ADDENDUM NO. 2

Date: March 21, 2024

Project: West Regional Library Renovation
Cary, NC

SHEET DATA
ELECTRICAL DETAILS

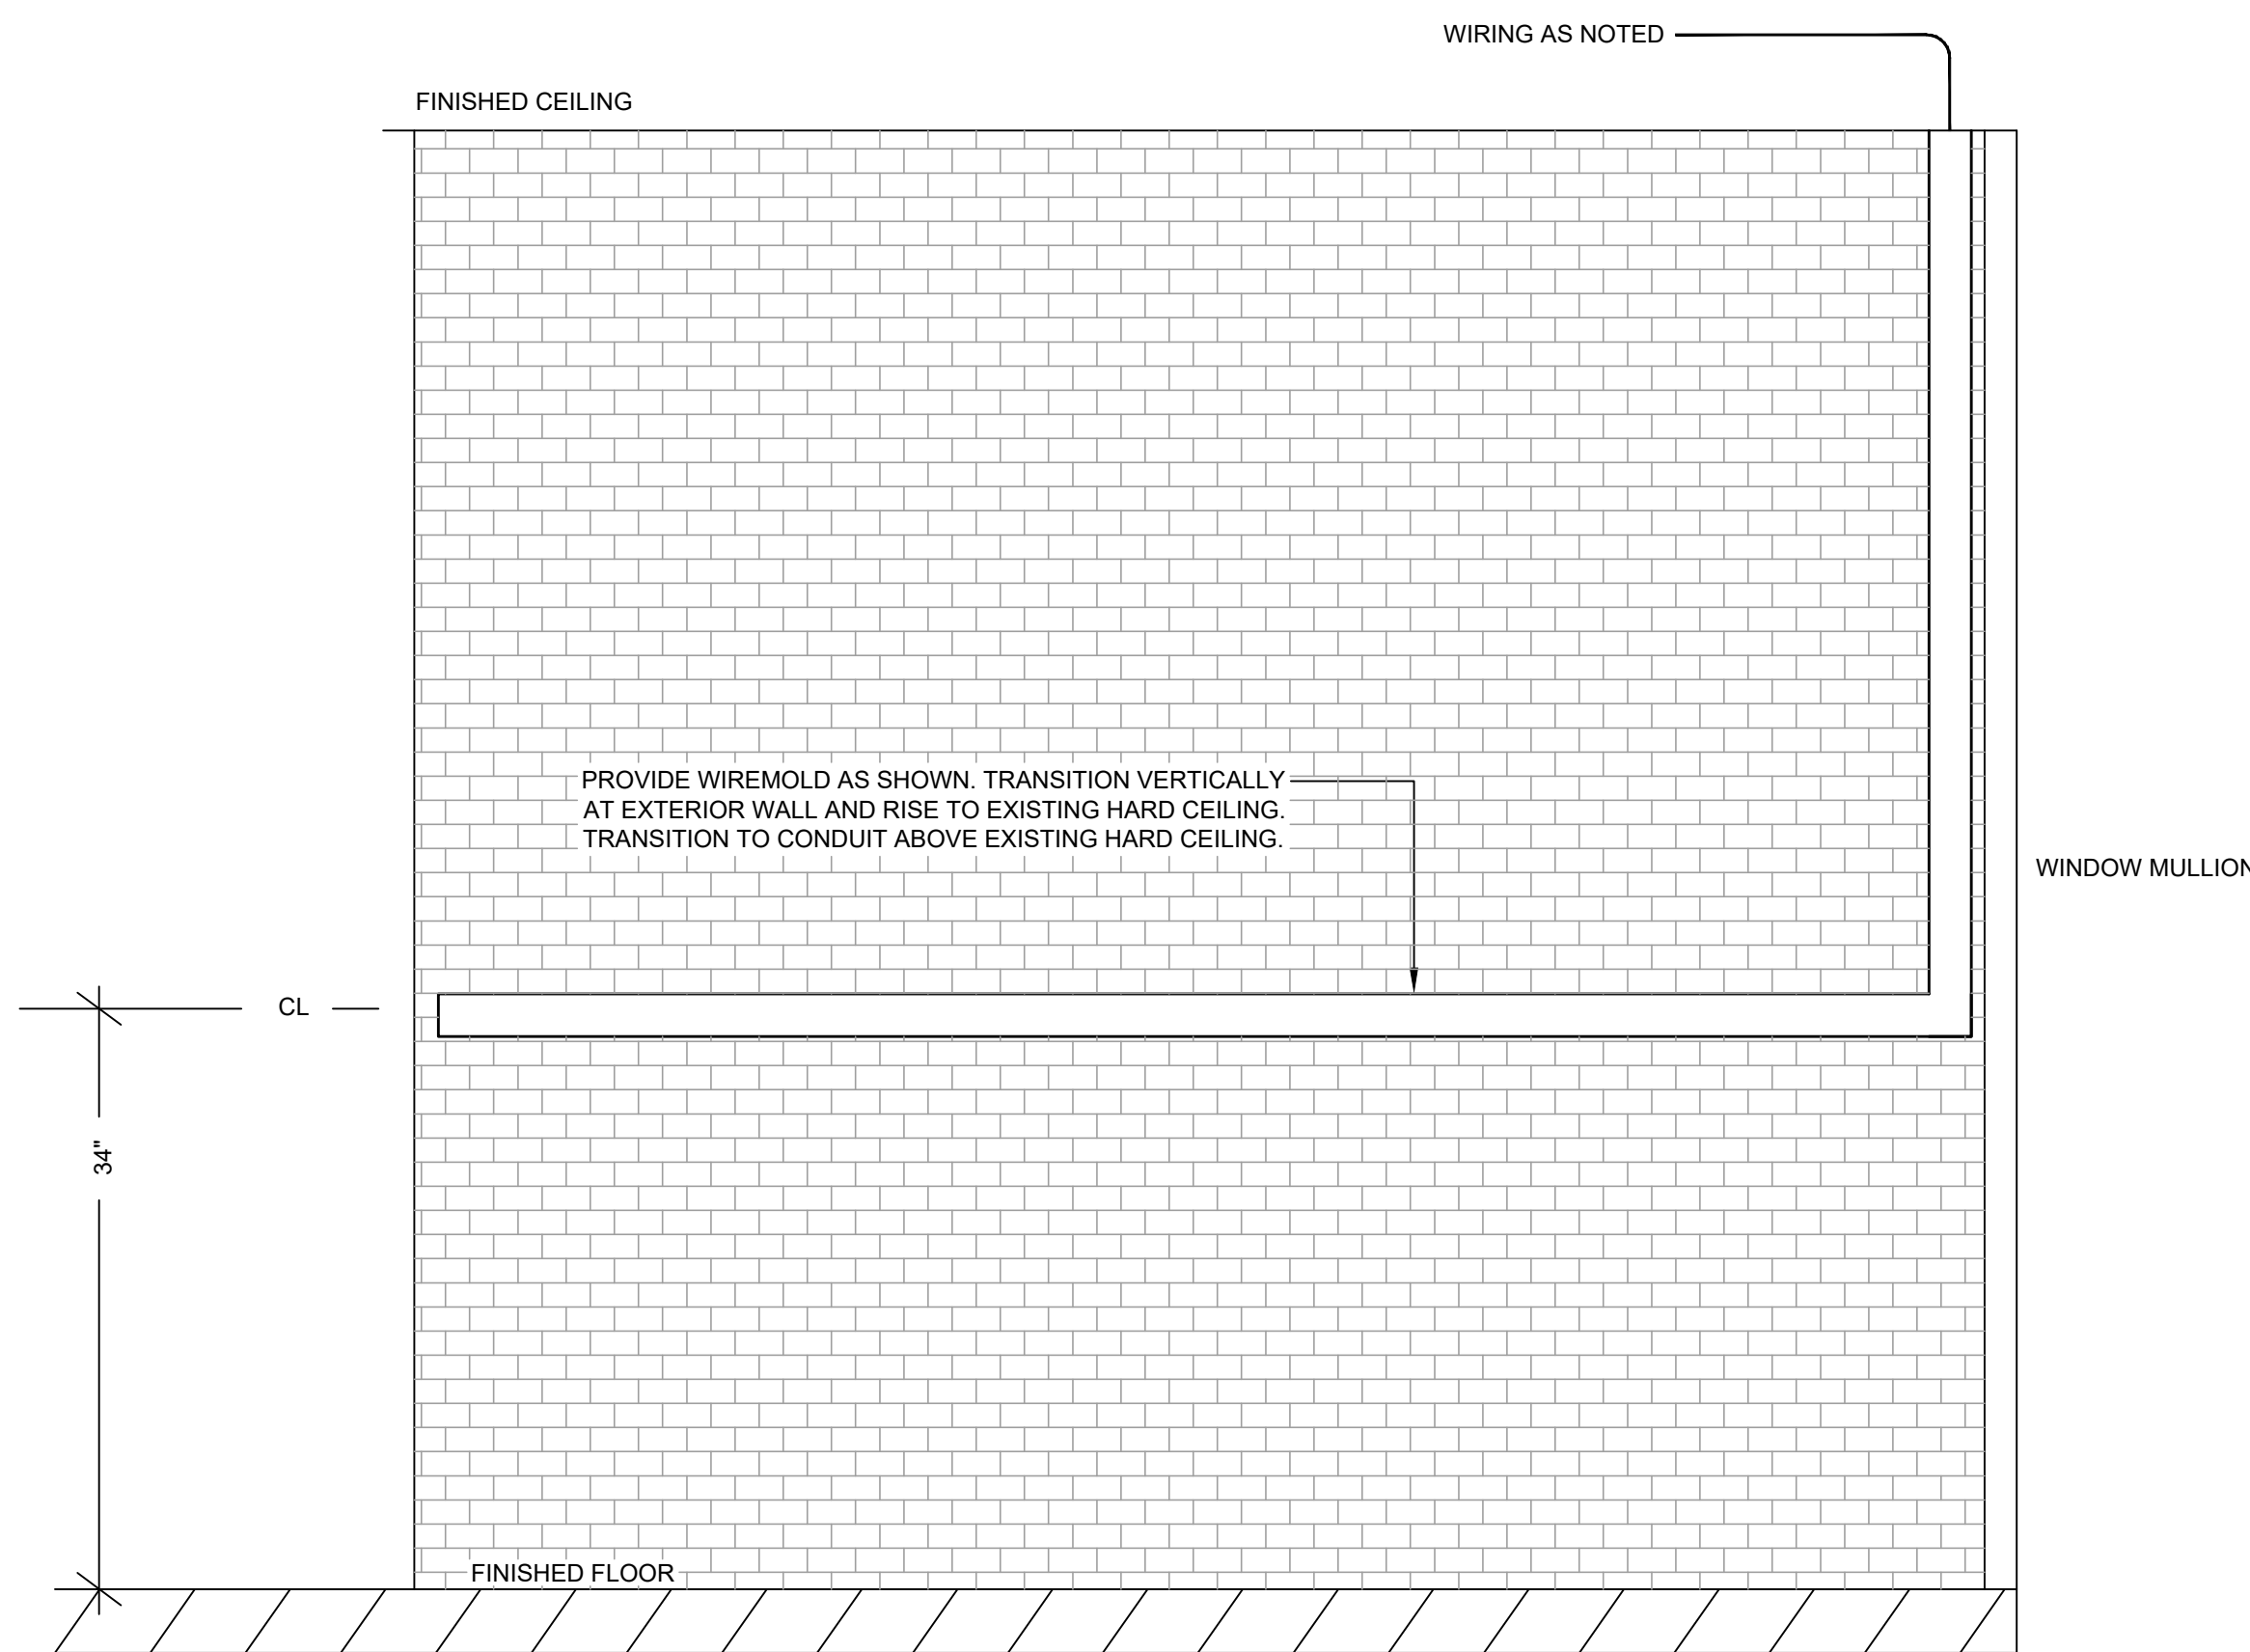
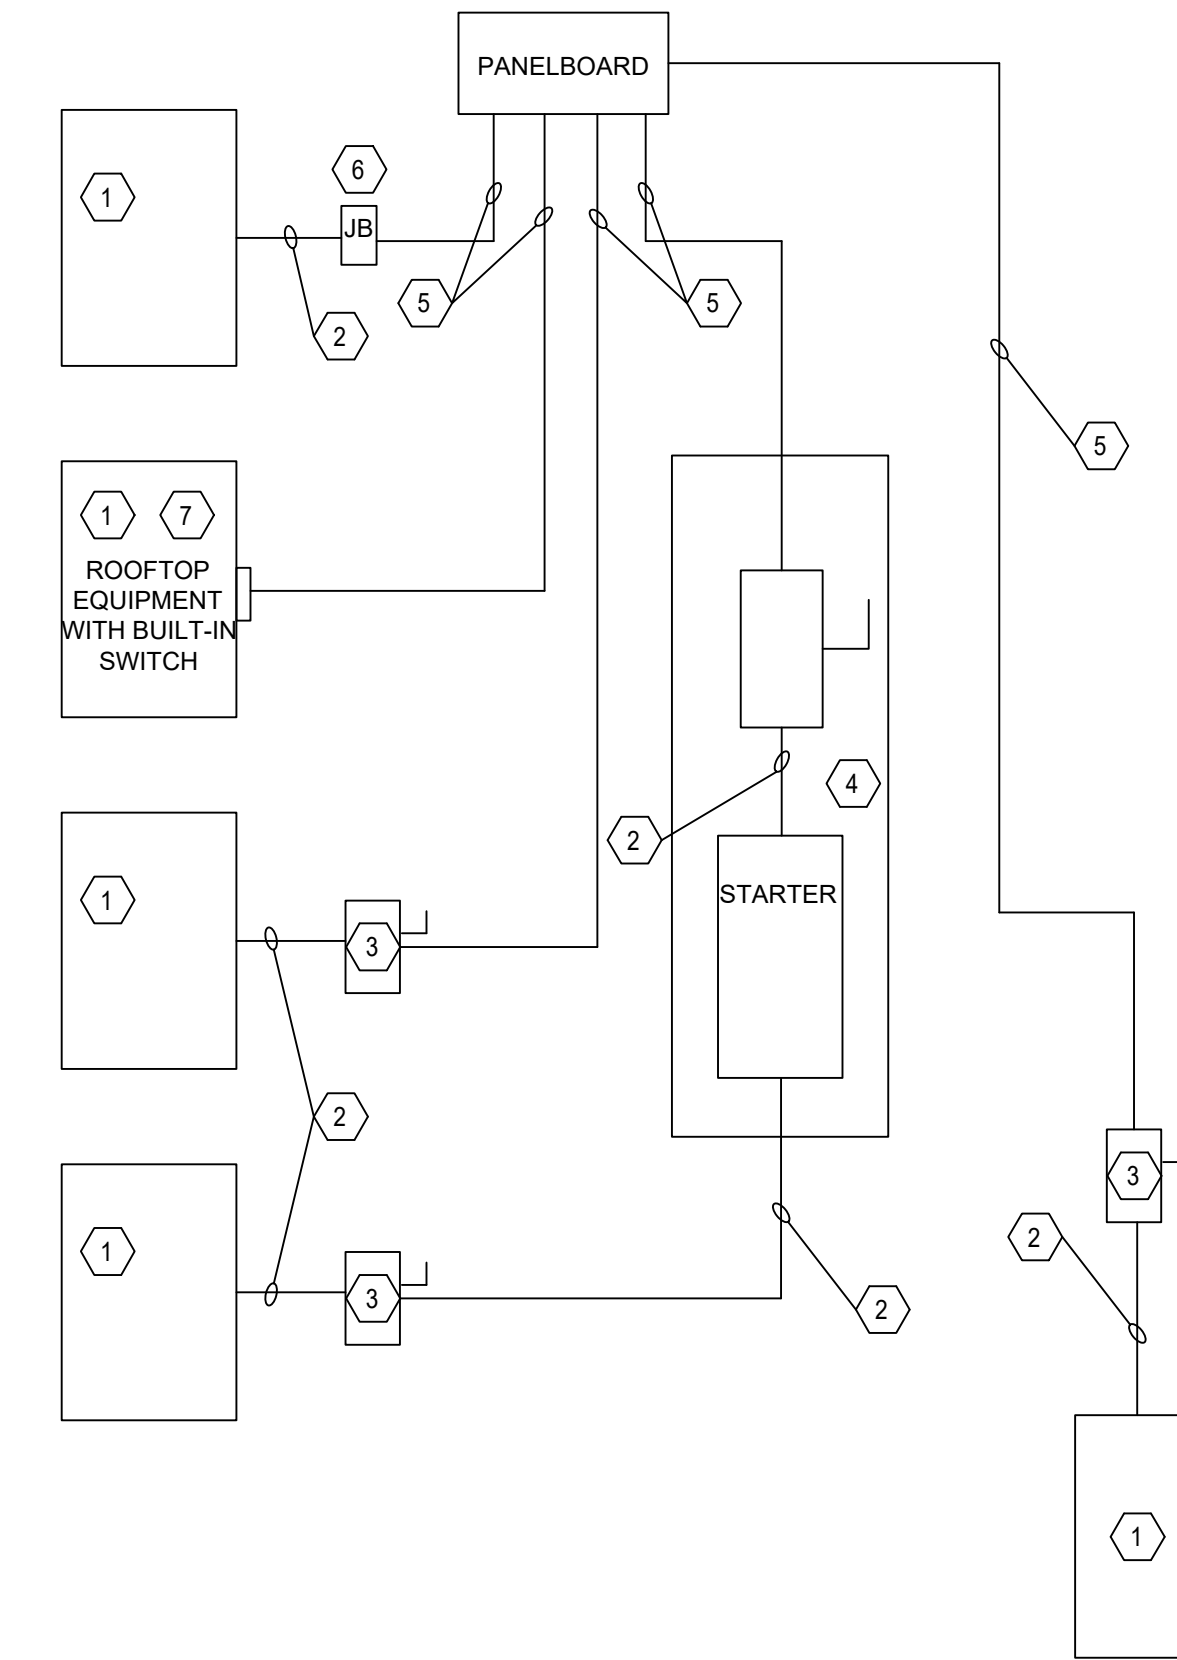
ITEM 21: Sheet E501- sheet has been **revised** to outline responsibilities between Divisions 23 and 26 as it relates to disconnects and final connections.

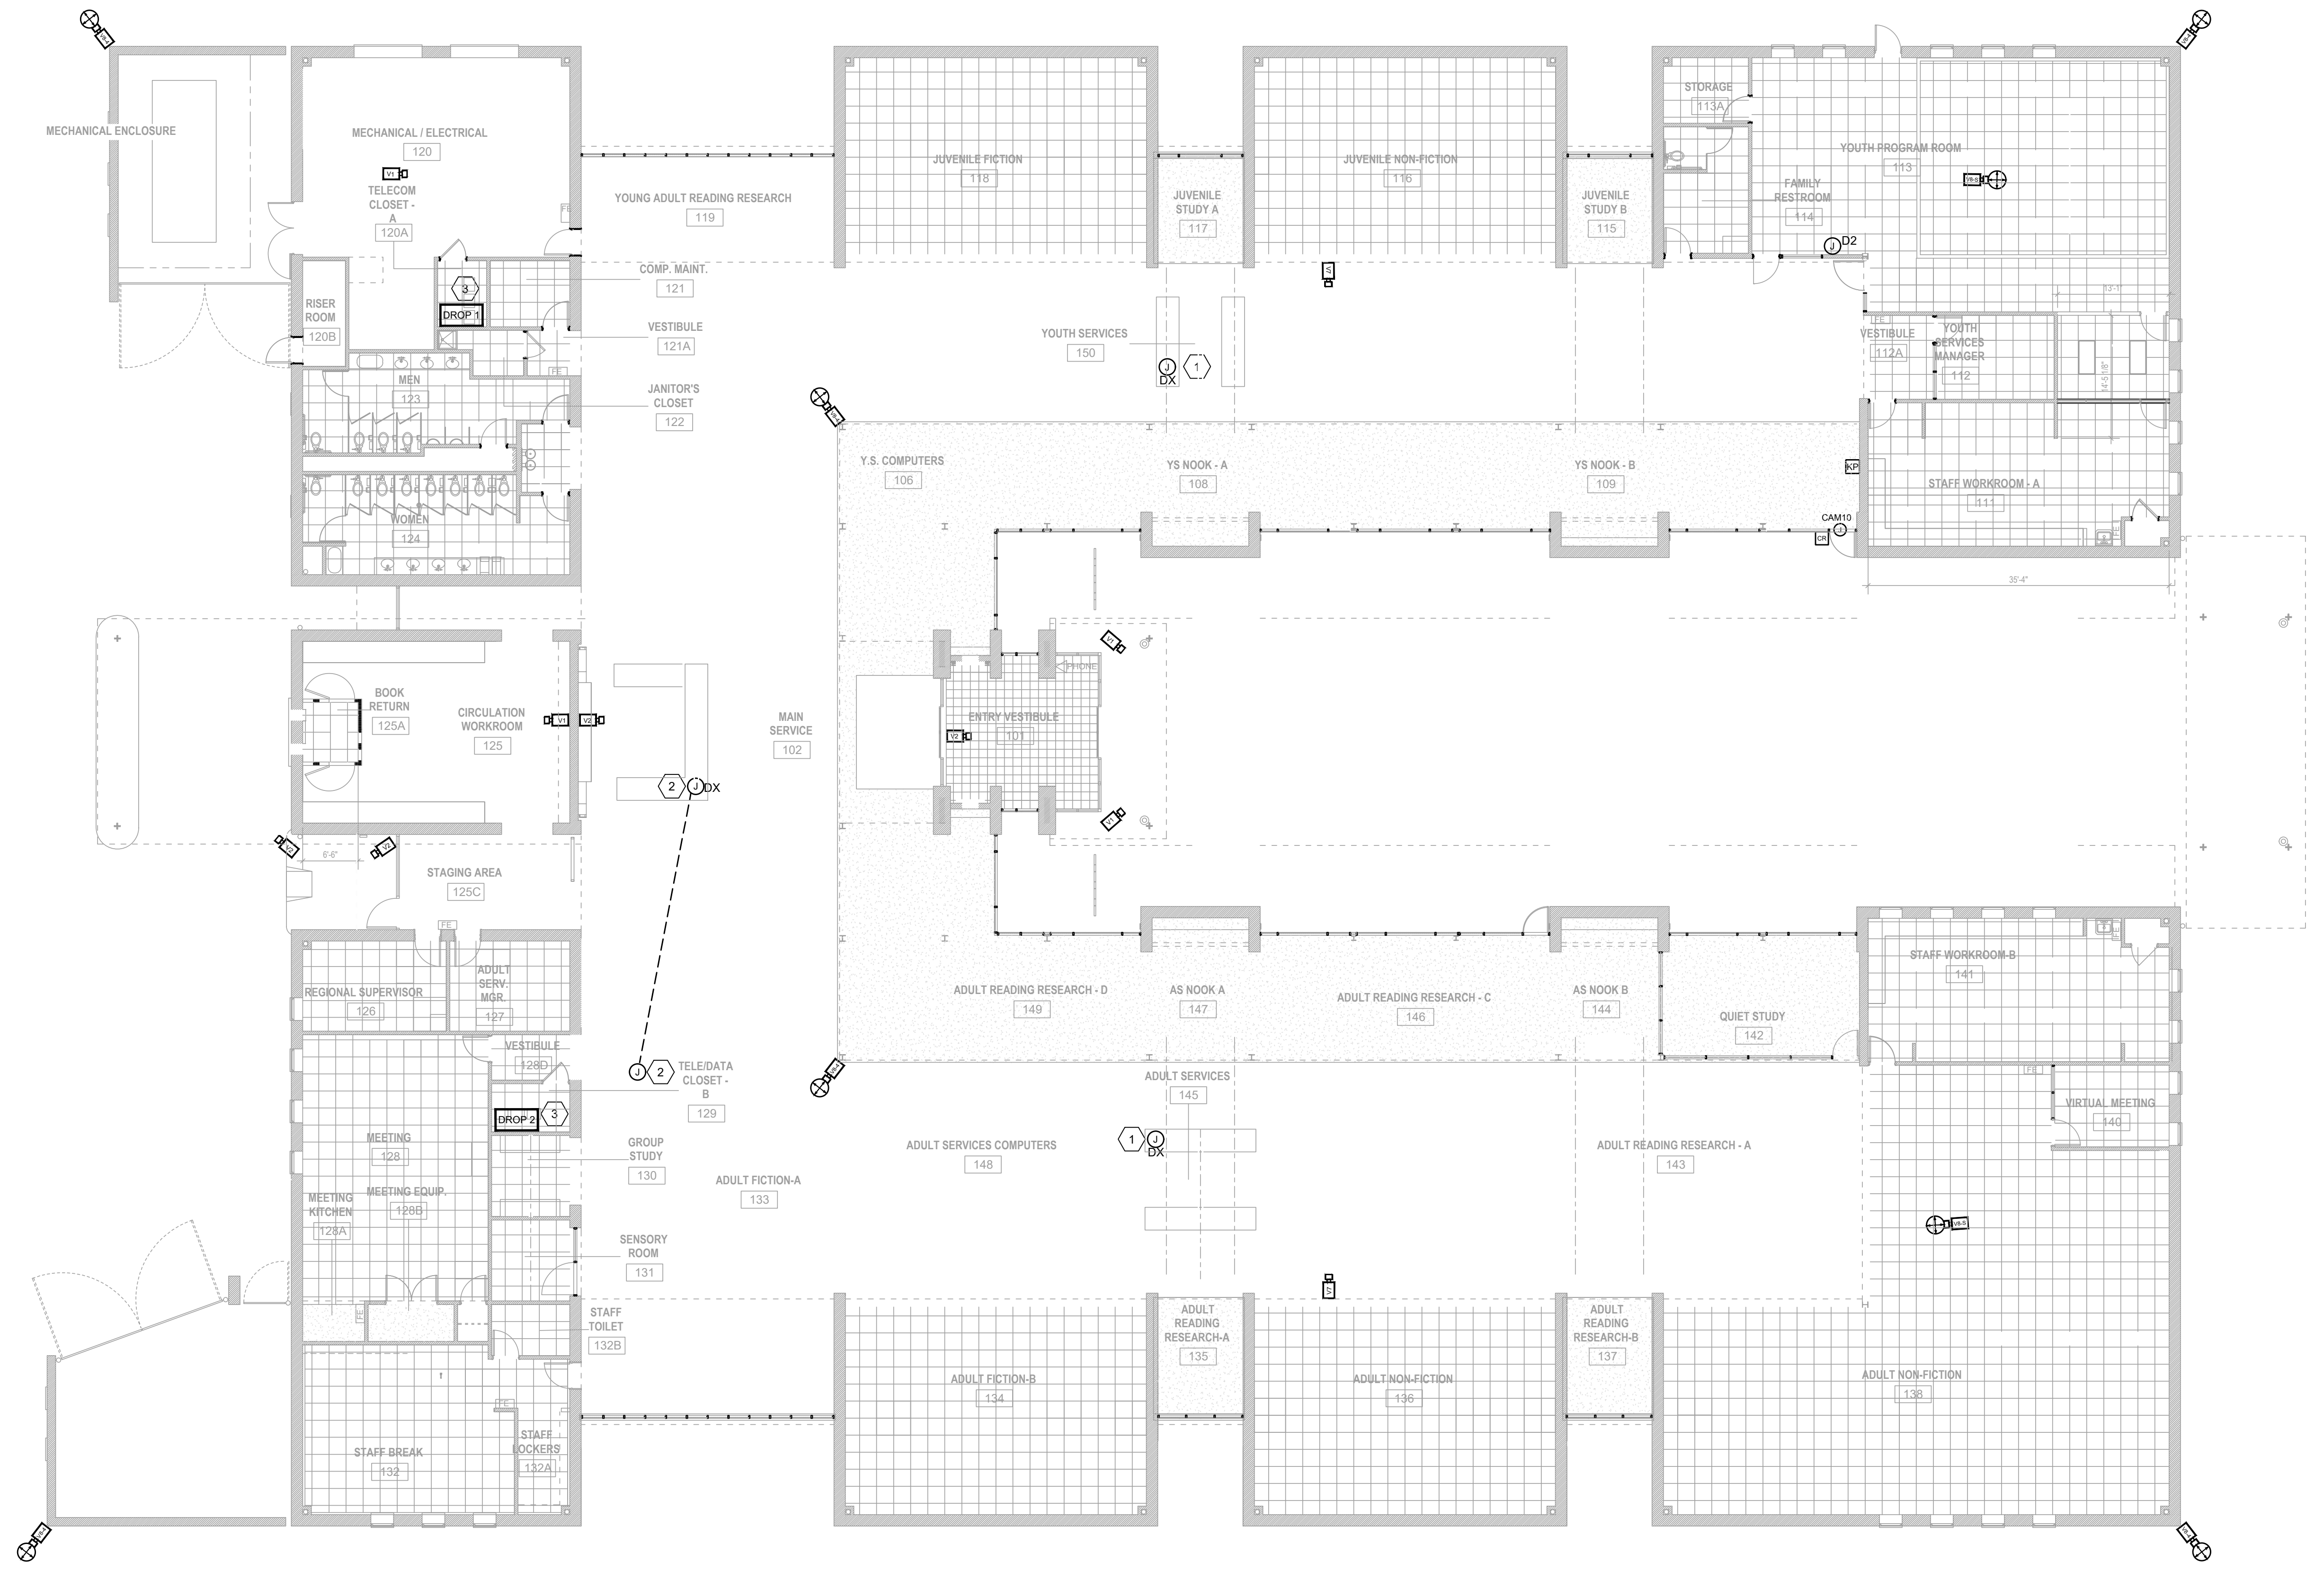
ITEM 4: Question: There is a lump-sum allowance #1 for telecom but sheet SEC-200 says, " DIVISION 26 CONTRACTOR IS RESPONSIBLE FOR POWER AND CONDUIT ONLY. INSTALLATION OF WIRING AND DEVICES WILL BE BY THE DIVISION 27 CONTRACTOR." Can you please clarify what is the scope for Division 27 (Telecommunication) contractors as a part of our base-bid?

Response: There is no Division 27 work as part of the base bid, only in the allowance No. 1. **Refer to** Allowances Specification Section 012100. General Note #2 on Sheet SEC-200 has been **revised** to clarify that installation of wiring and devices will by the Division 28 contractor.
